**Herschel**

Subject: Mech. Interface Meeting with Spire

**Comments on SPIRE Configuration Drawings (Issue 16, dated 28/08/2002)****27/09/02**

Source: HP-2-ASED-TN-049, Issue 1, Analysis Results

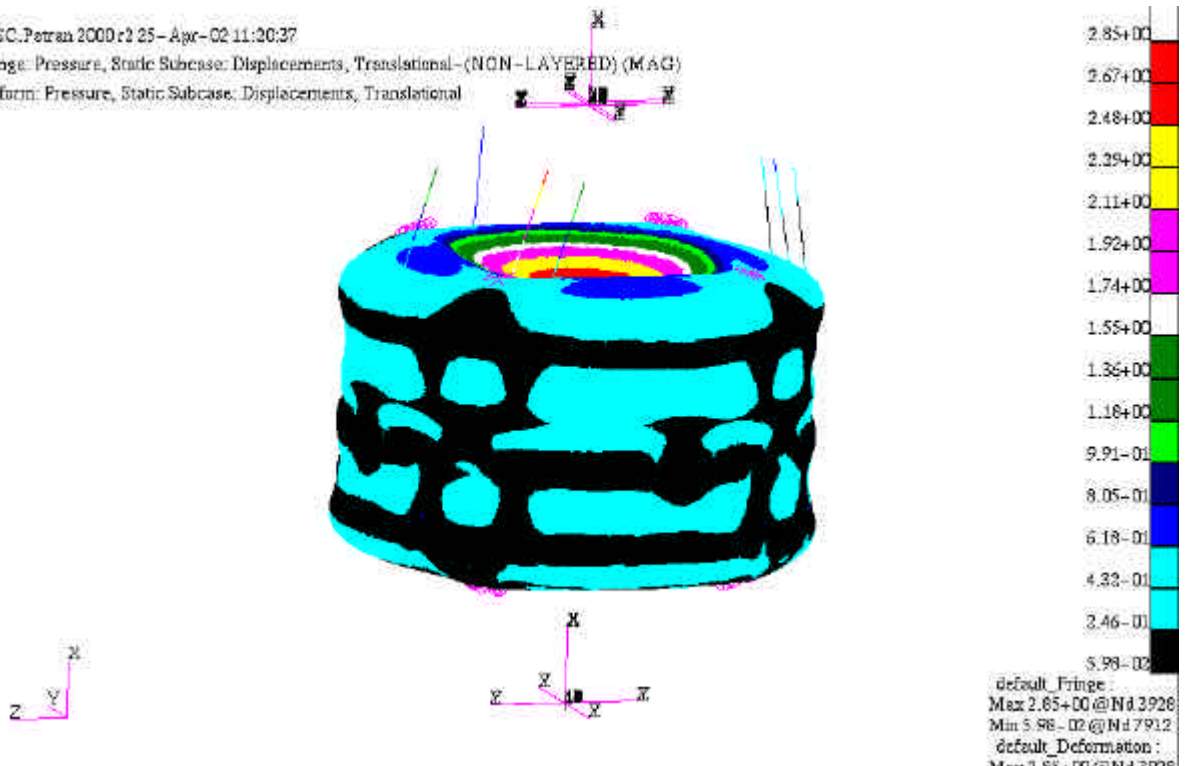
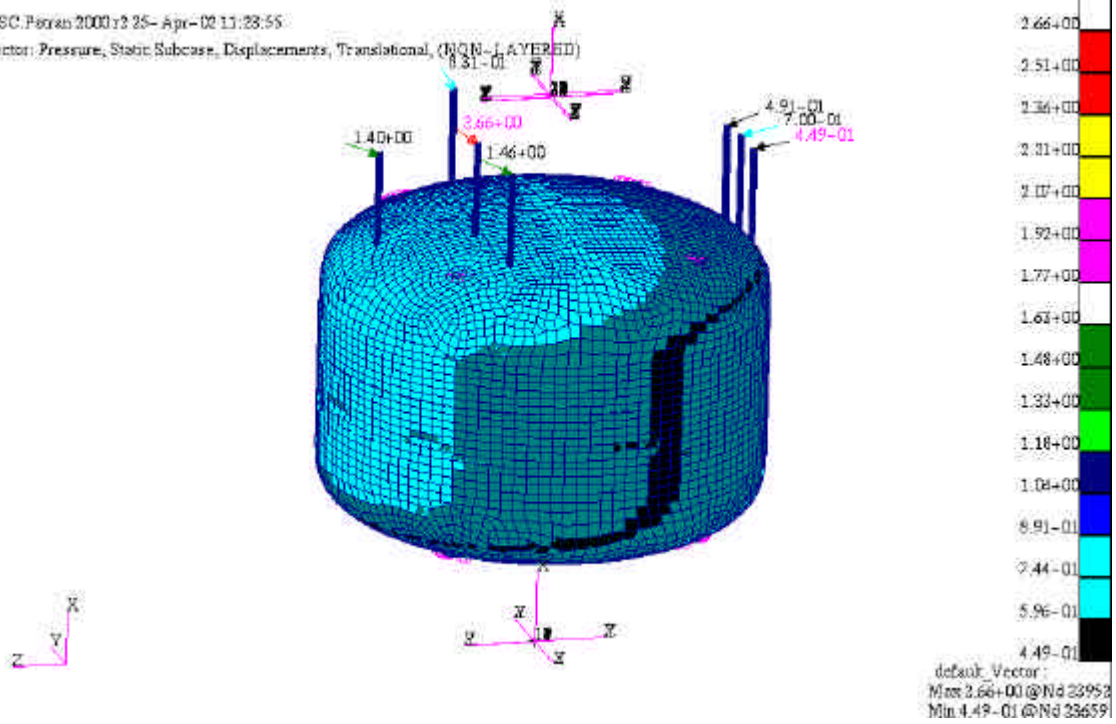
→ 10 mm are an envelope for the level 0 I/F of the instruments

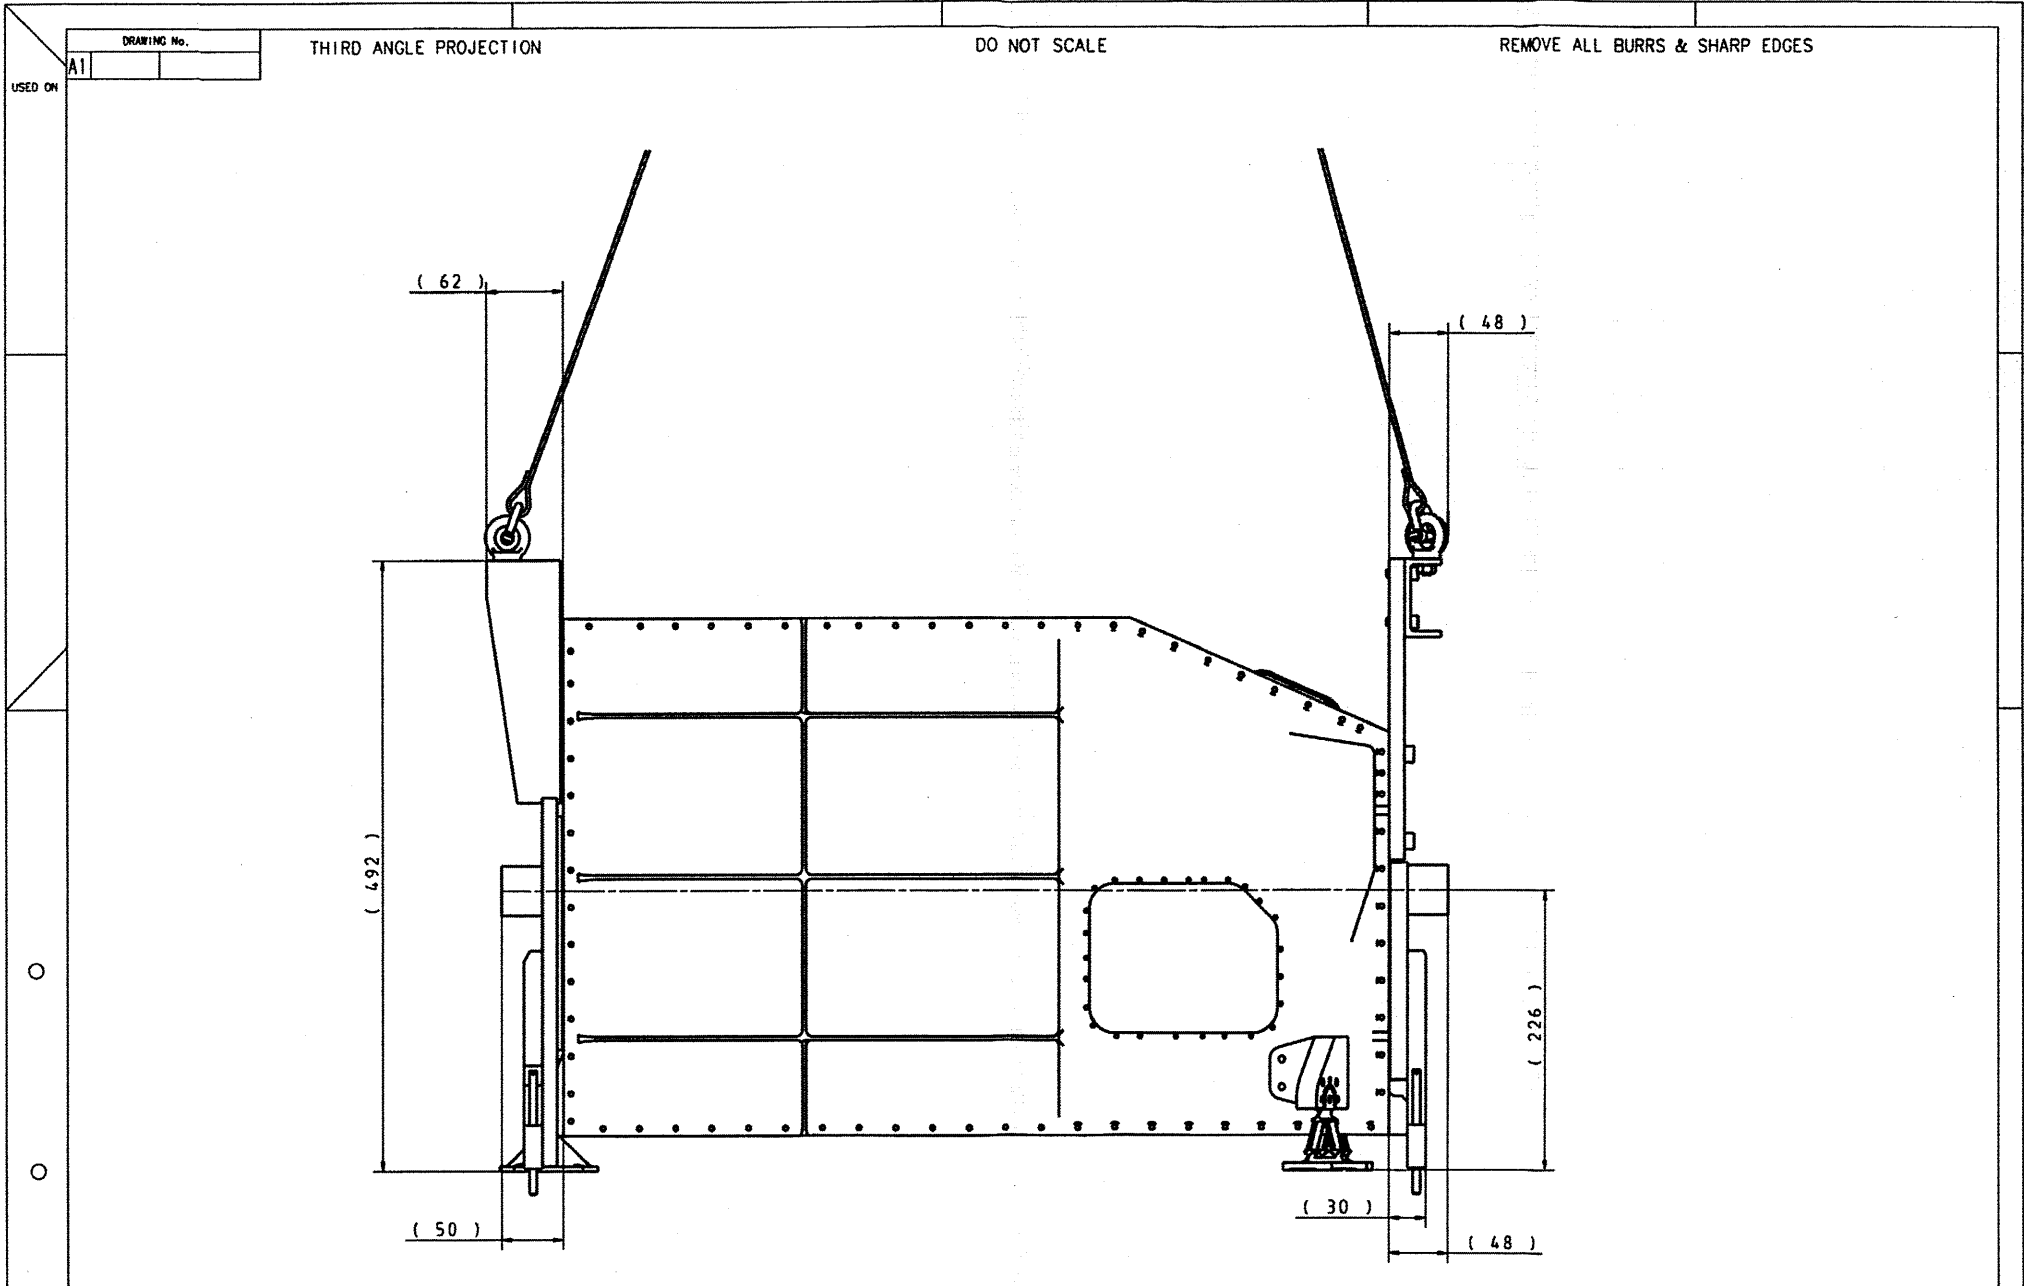
1. Sheet 1 of 7 and other sheets: Cryostat hole is 288mm. Please update.
2. Sheet 1 of 7: Comment Alternative attachment points: Level-1 strap is connected to ventline, not to Optical Bench. Update.

3. Sheet 1 of 7: Optical Reference Cube changed from 25x25x25mm to 31x31x31mm. Change to be discussed in framework of thermal and straylight impact of alignment cube, if not dismantled.

4. Sheet 1 of 7: Photometer and Spectrometer BDA feedthroughs to be added
5. Sheet 1 of 7: Instrument shield not up-to-date, could be replaced by update
